Groundwater Application Review Summary Form

Application # G- 19482

GW Reviewer Gabriela Ferreira Date Review Completed: March 13, 2025

SUBJECT: Scenic Waterway Interference Evaluation

Well Statistics

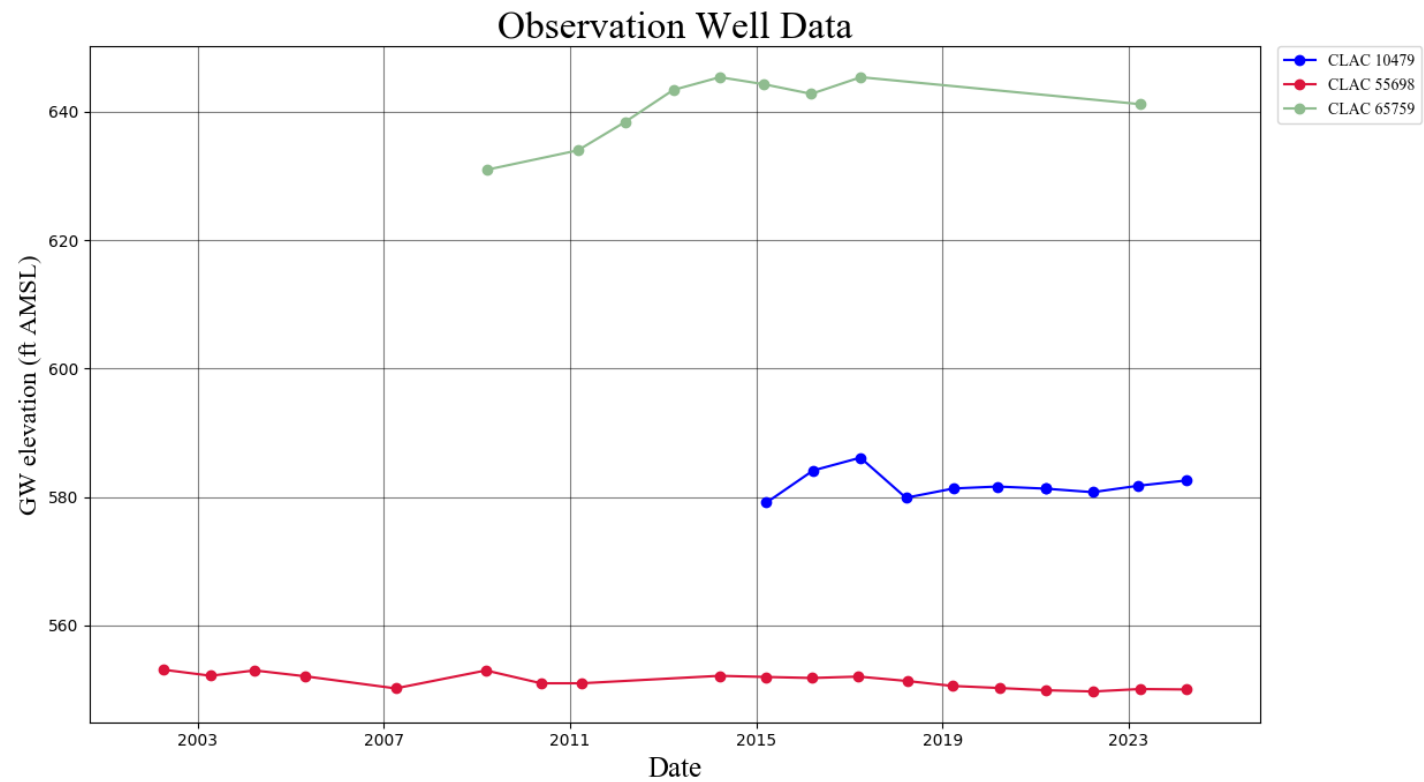
Water level data from three wells were selected for evaluation based on location and aquifer system. Two wells, CLAC 65759 (~5 miles northeast) and CLAC 11435 (~2 miles north), are near the western margin of the Sardine Formation (hydrogeologically similar to the Molalla Formation) and may be interlayered with the Troutdale Formation. The third well, CLAC 10479 likely produces from the Molalla Formation, although the Troutdale Formation is present at surface. The three wells have relatively stable water levels, with 10 to 15 feet of variability observed over the available record. Although somewhat limited, the available groundwater level data suggests that groundwater for the proposed use is not over appropriated.

Permit condition 7RLN is recommended to assess potential future injury concerns, and as a means to monitor long-term groundwater conditions in this area.

Well Location Map

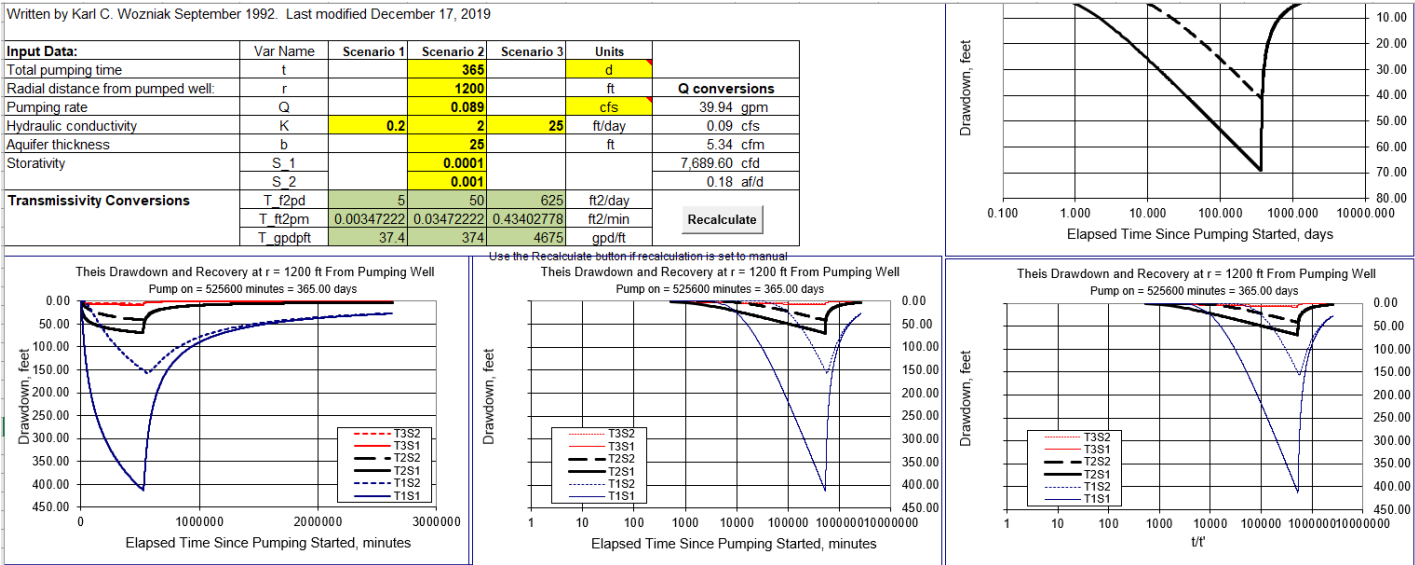
A4. **Comments:** The proposed POAs/POU are located approximately 4 miles southeast of Molalla. The applicant proposes irrigation use on 113.8 acres by two wells to be constructed, for a maximum instantaneous rate of 0.50 cfs (~225 gpm) and maximum annual volume of 243.0 acre-feet.
